RE: Materials License 21-08317-01, Munson Medical Center

From: Forster, Sara
Sent: Tuesday, November 14, 2017 6:37 AM
To: Song, Taehoon; Pavon, Sandy; Sandrik, Lauren
Subject: FW: Additional Information for Munson Medical Center Amendment, Lic. 21-08317-01, CN600842
Attachments: NRC THV decommissioning and Forster MD update October 24 2017.pdf; Forster NRC Preceptor Verifications.pdf; Traverse Heart and Vascular Close-Out 9-17 survey + map.pdf

From: Forster, Sara [mailto:Sara.Forster@nrc.gov]
Sent: Monday, November 13, 2017 3:20 PM
To: Aurand, Dennis <daurand@mhc.net>
Subject: Additional Information Request re Munson Medical Center Amendment, Lic. 21-08317-01, CN600842

Hot Lab, Imaging Area and Stress Rooms

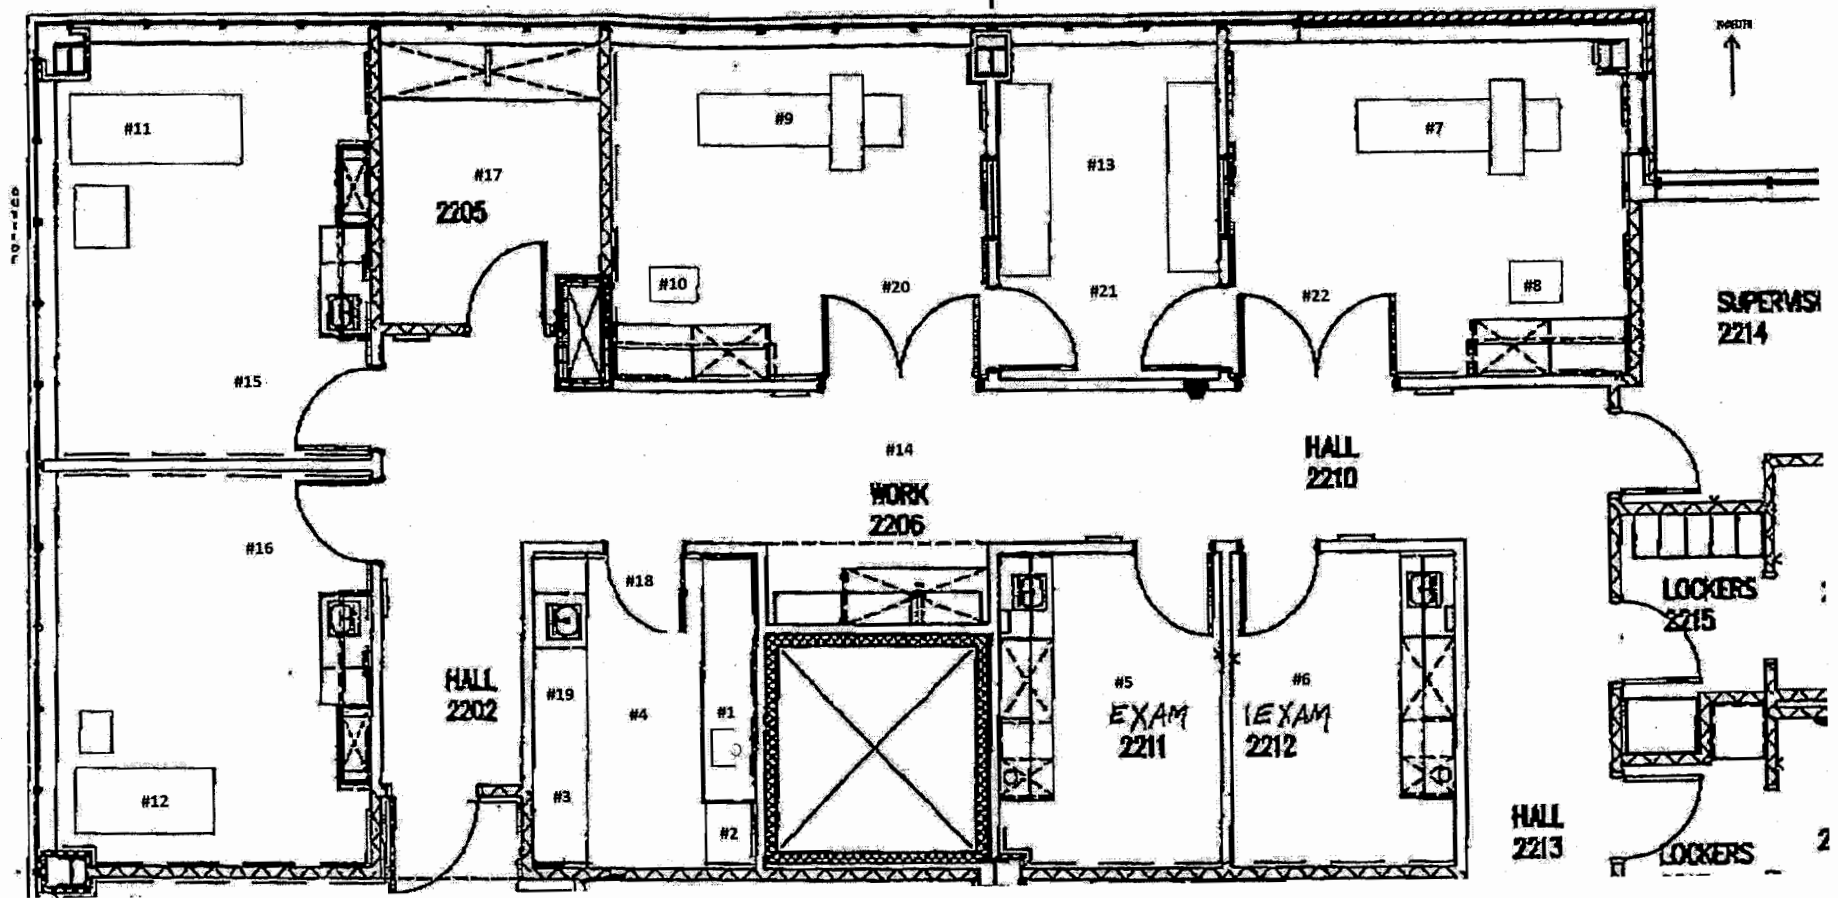
4. Regarding closeout surveys for the Suite to be removed from the license, please provide a copy of the final area survey results, including a diagram of the area surveyed with wipe locations keyed to spots noted on the diagram.

Removable Contamination: No area within the department demonstrated removable contamination excess of 50 dpm's.

Area	Result in dpms
#1 Dose Prep	0
#2 Waste Storage	4
#3 Package Receipt	2
#4 Hot Lab Floor	50
#5 Exam Room	0
#6 Exam Room	8
#7 Camera	0
#8 Acq/Processing Area	0
#9 Camera	0
#10 Acq/Processing Area	0
#11 Treadmill	40
#12 Treadmill	0
#13 Acq/Processing Area	10
#14 Hallway	0
#15 Treadmill Floor	0
#16 Treadmill Floor	0
#17 Exam Room	0
#18 Hot Lab Floor	0
#19 Hot Lab	2
#20 Imaging Room Floor	0
#21 Processing Room Floor	2
#22 Imaging Room Floor	0

Maximum removable contamination = 50 dpms
